TEMPORARY REVISION**TR-OÄM-20-244/b****Instrument Panel Version D20-3110-00-00****supersedes TR-OÄM-20-244/a****and****TR-OÄM-20-245/b****External Alternator****supersedes TR-OÄM-20-245/a****and****TR-OÄM-20-267/a****NVFR****supersedes TR-OÄM-20-267**

This Temporary Revision TR-OÄM-20-244/b and TR-OÄM-20-245/b and TR-OÄM-20-267/a are approved in conjunction with the Optional Design Change Advisories OÄM 20-244/e and OÄM 20-245/c and OÄM 20-267/b and are valid in conjunction with the latest revision of the DV 20-100 Airplane Flight Manual until this temporary revisions have been incorporated into the Airplane Flight Manual.

Doc. No. 4.01.20-E	TR-OÄM-20-244/b &20-245/b&20-267/a	30-Jan-2013	Cover page 2
--------------------	---------------------------------------	-------------	--------------

Figure 1: Instrument panel, if OÄM 20-244 is installed

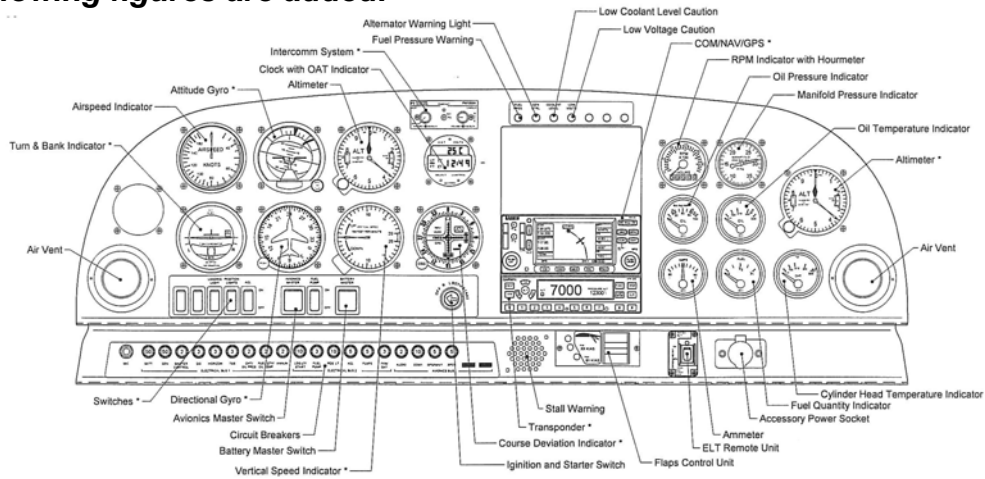
The following figures are added:
